ADDENDUM NO. C**DATE: 1/5/2025**

Community Day School Modernization
Merced, CA 95340
Client Bid No. 2025-5

DARDEN PROJECT NO. 2533
DSA File Nos. 24-35
DSA APPL. NO. 02-123716

ADC-AX01

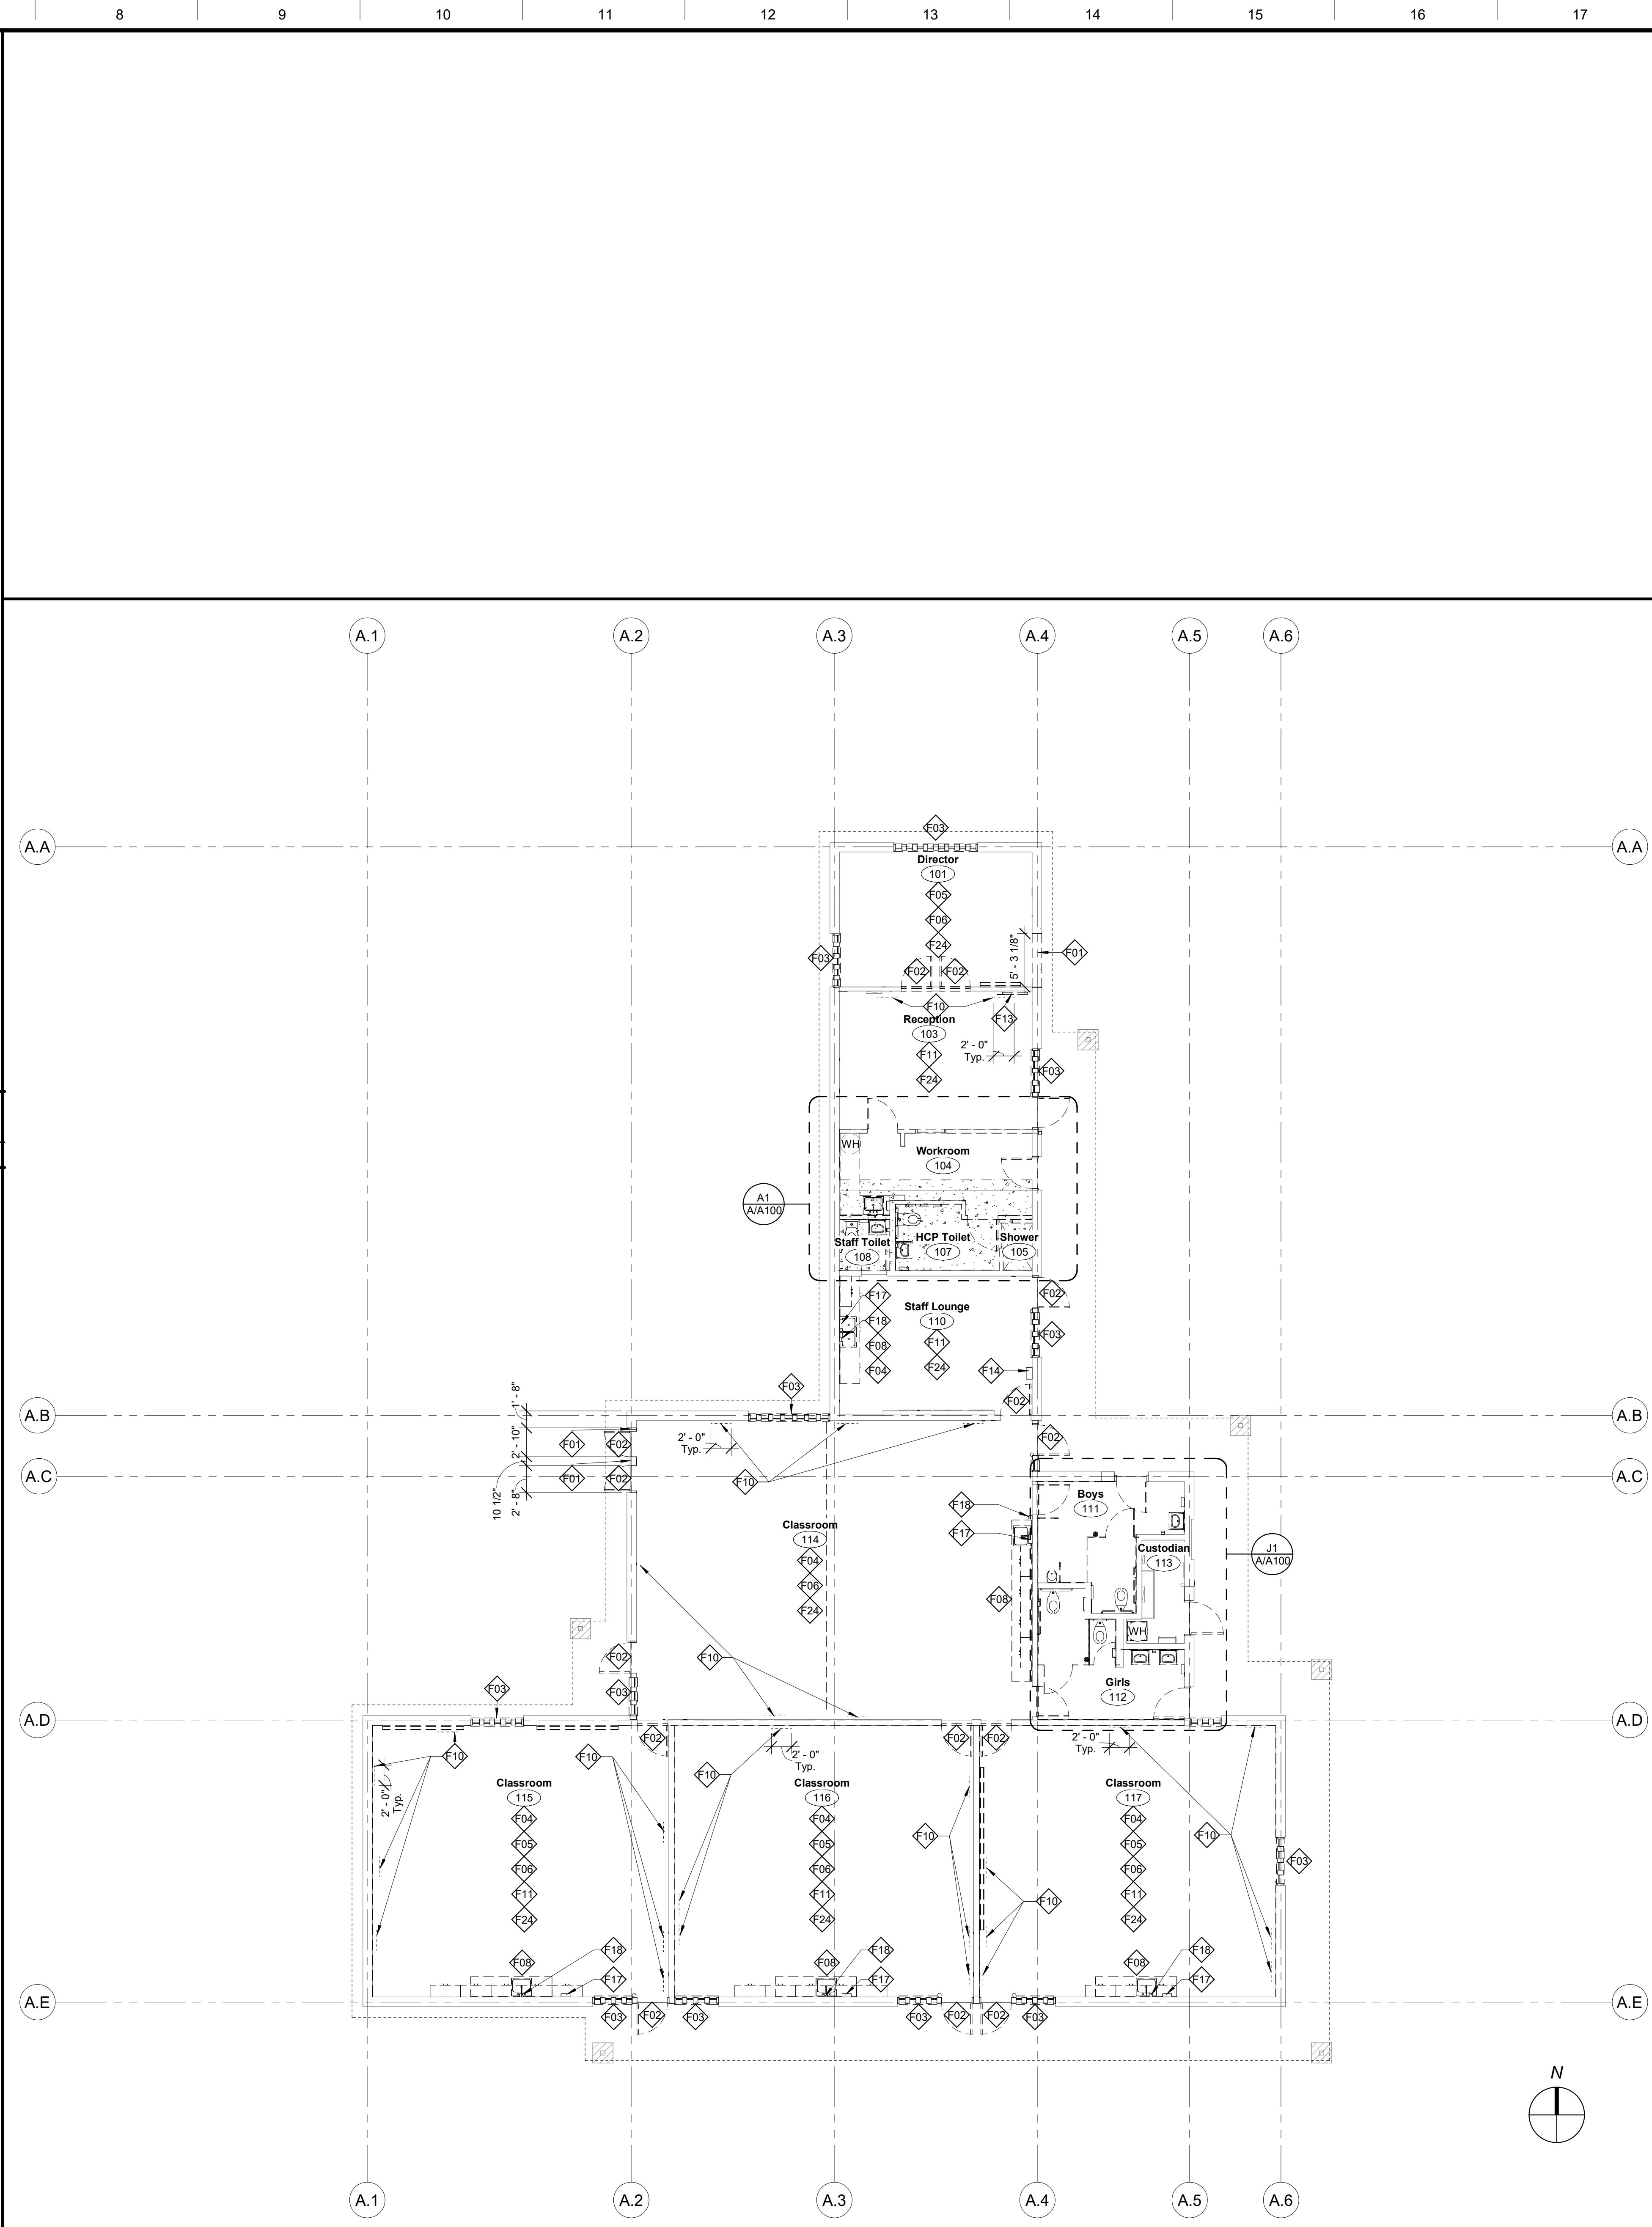
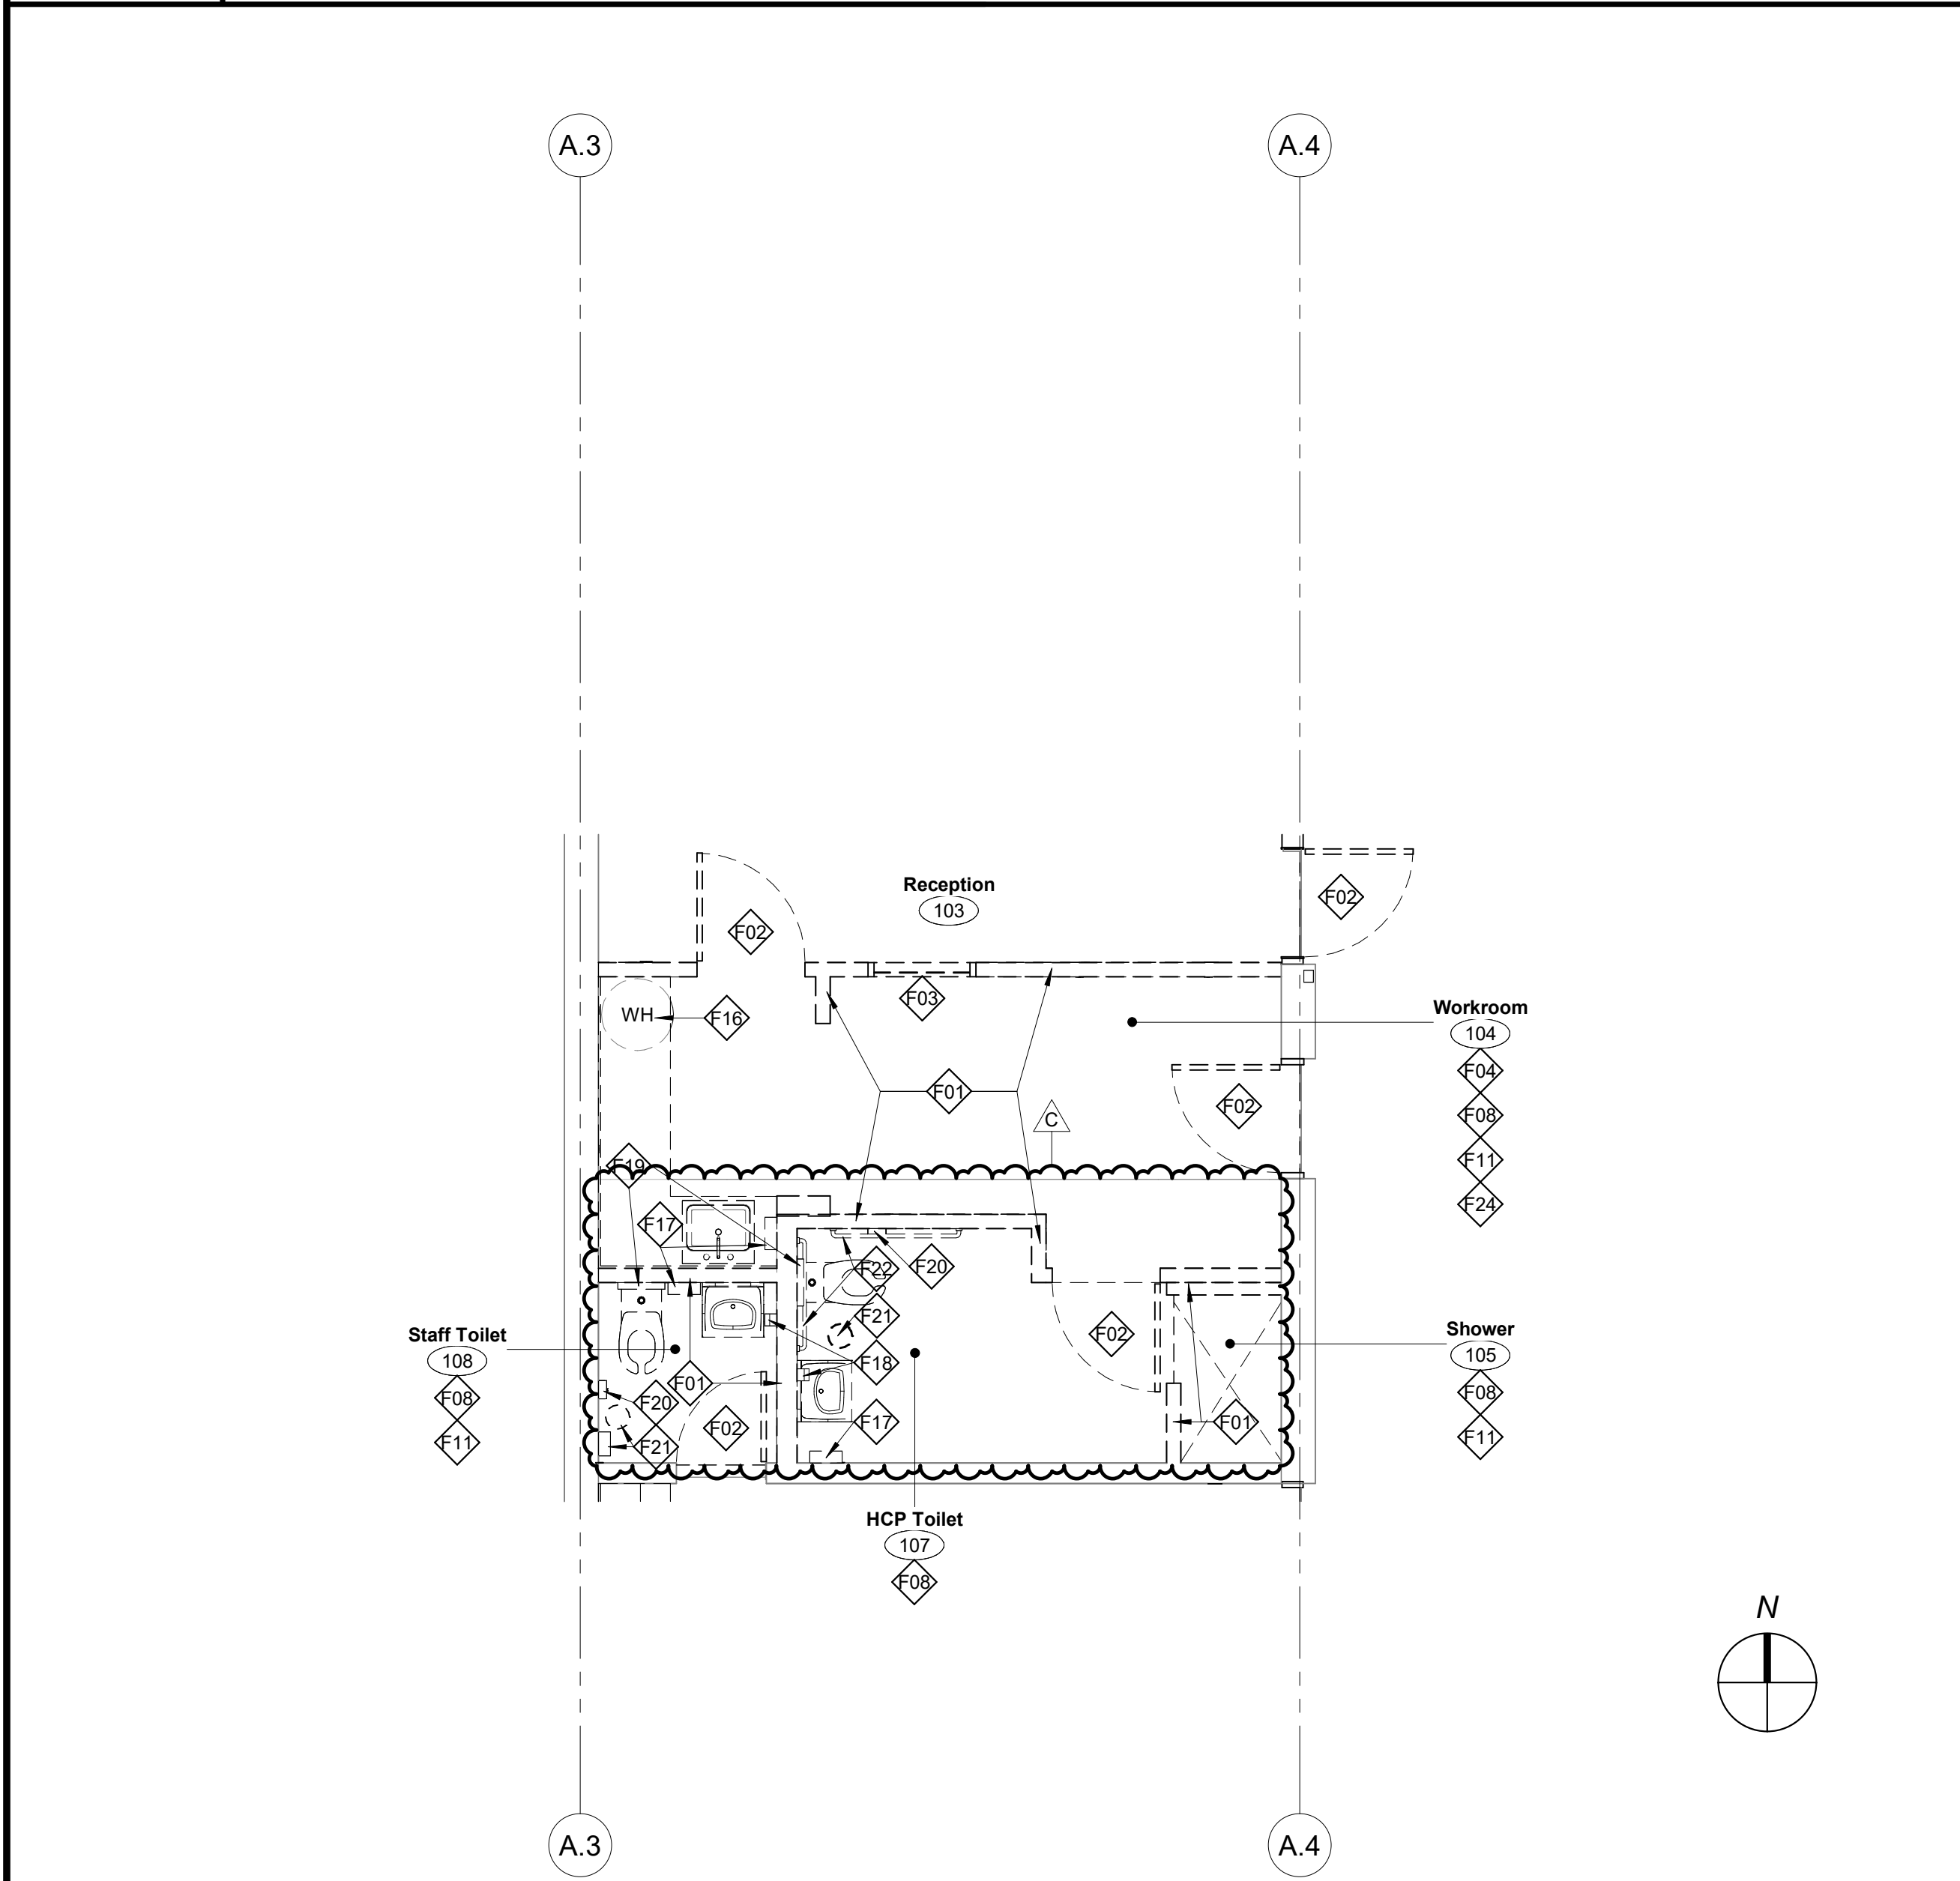
1. Refer to Sheet ADC-AX01. Demo Keynote 07 no longer included in project scope. Work to be performed in next project phase.

ADC-AX02

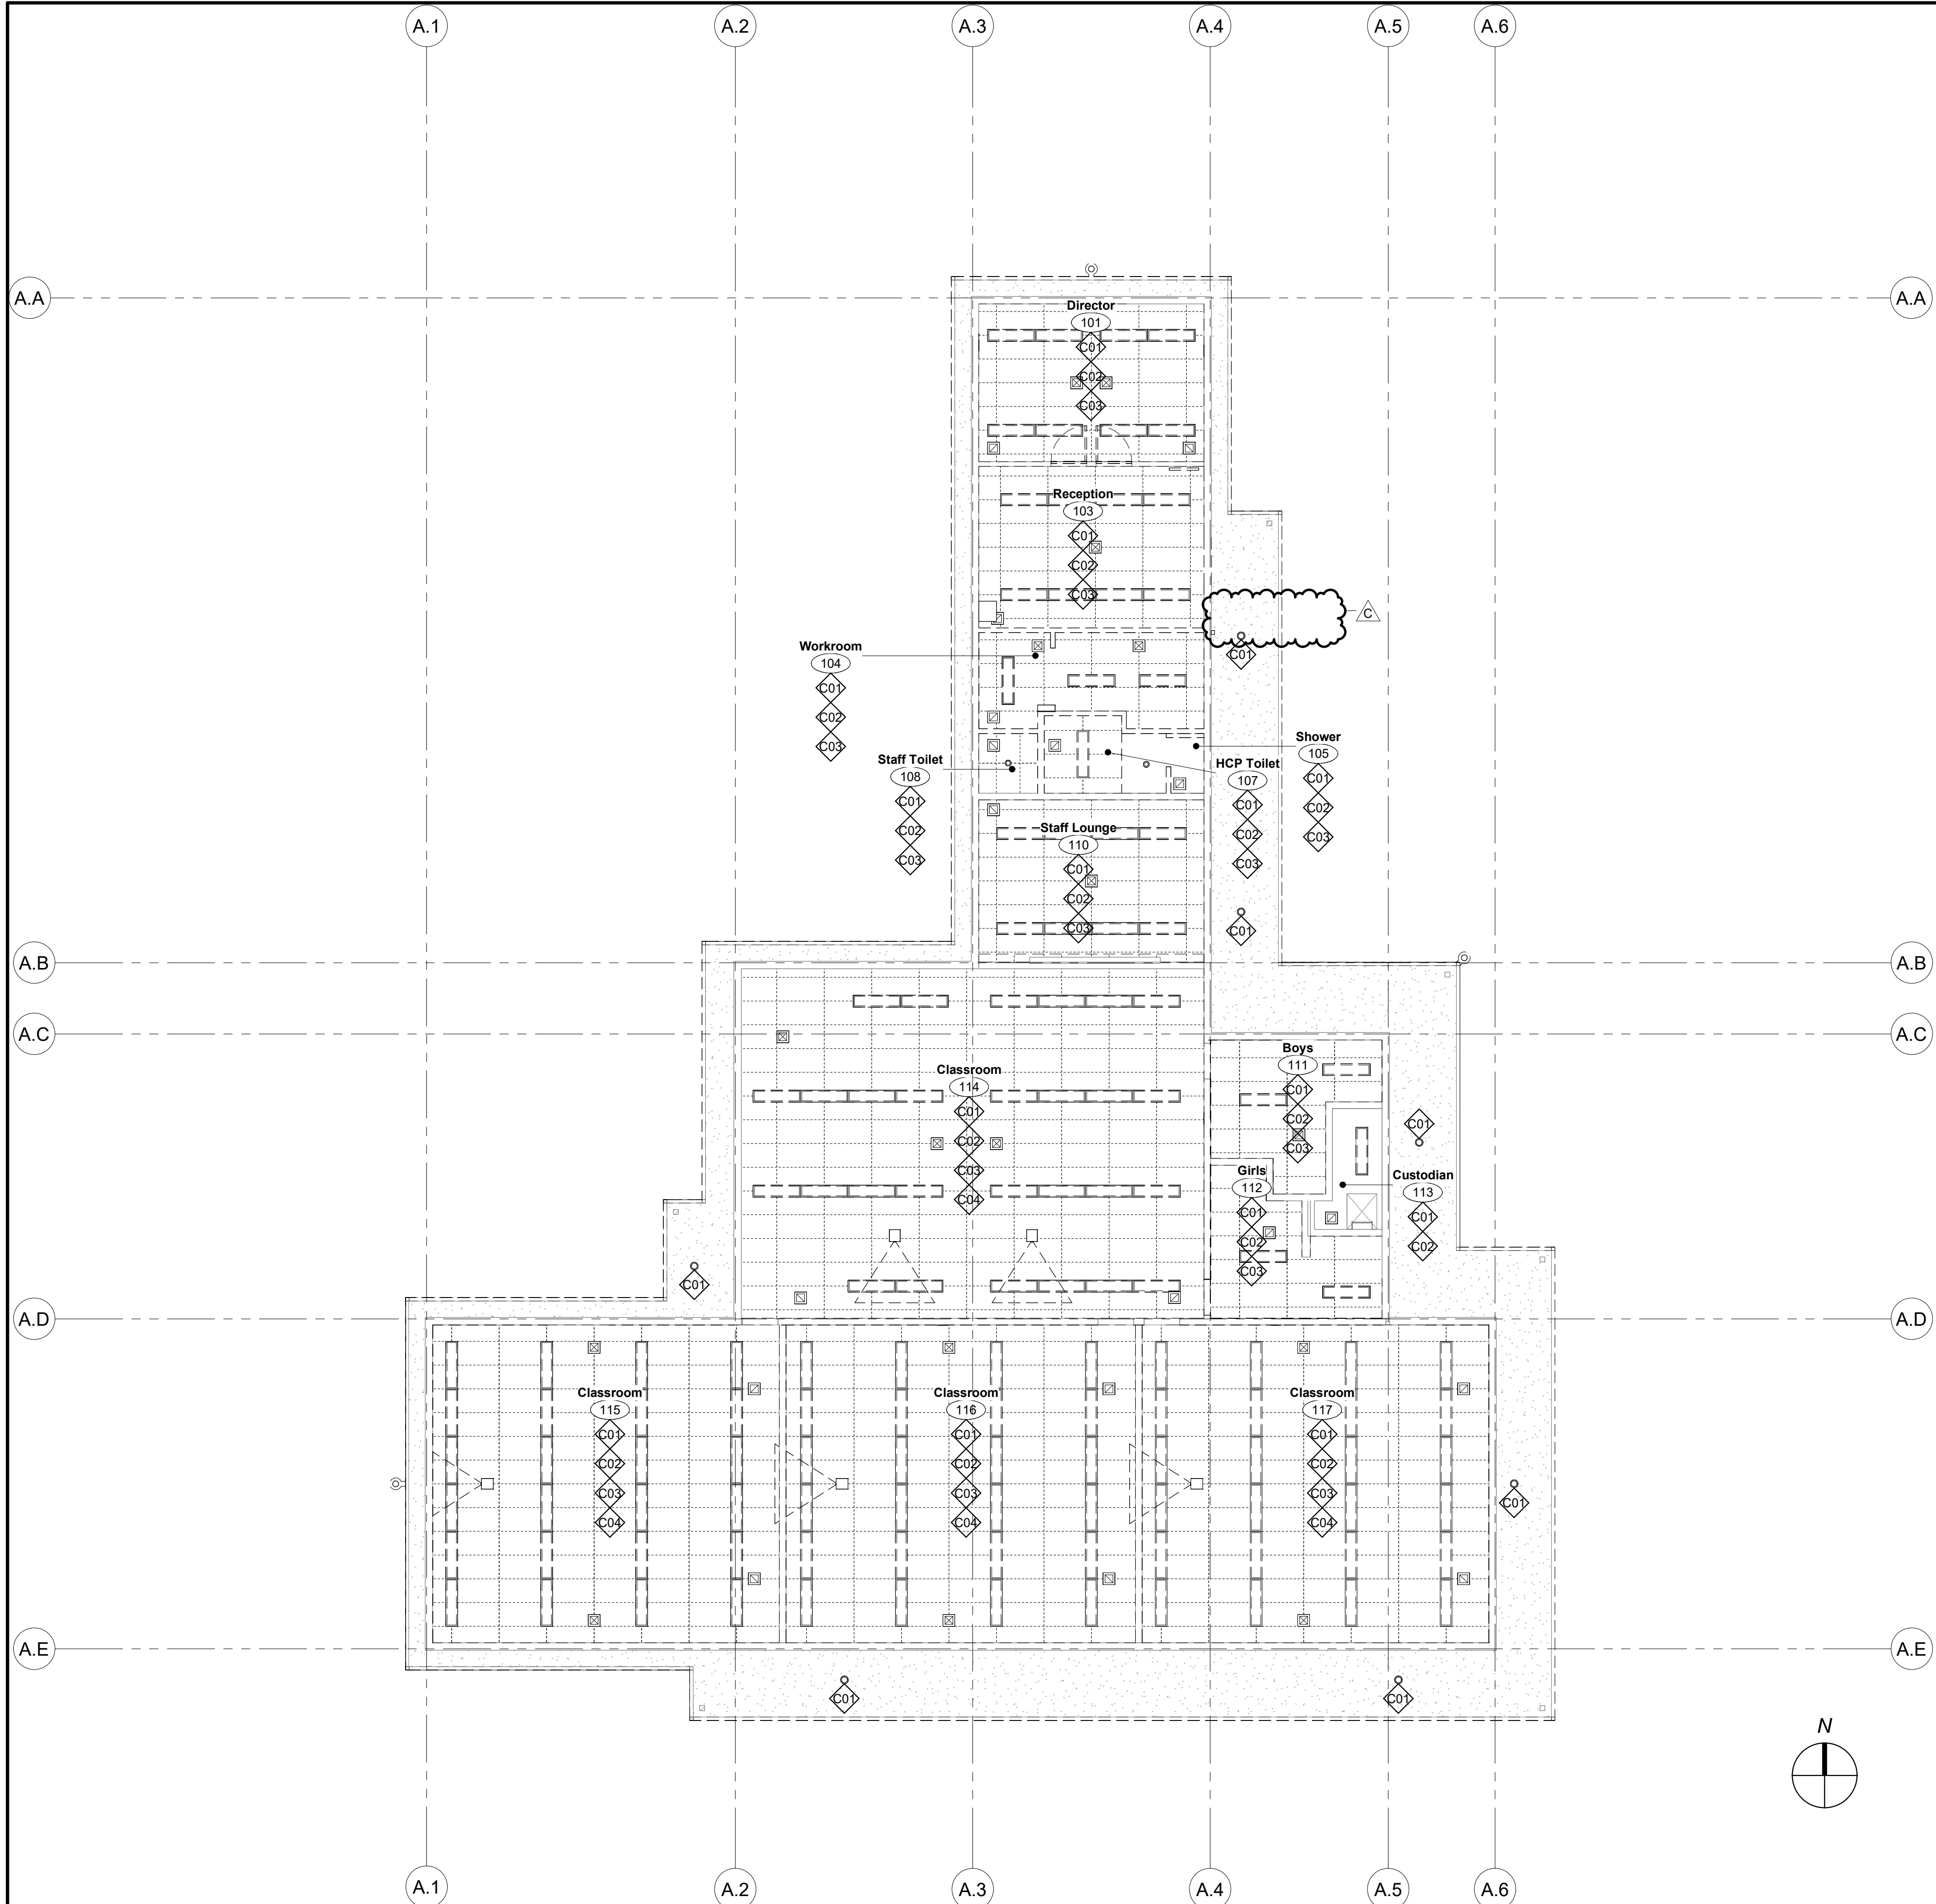
1. Refer to Sheet ADC-AX02. Refer to Keynote 04; reinstallation of scope to be performed in next project phase. Coordinate storage of removed items with Owner.
2. Refer to Sheet ADC-AX02. Keynote 05 no longer included in project scope. Work to be performed in the next project phase.
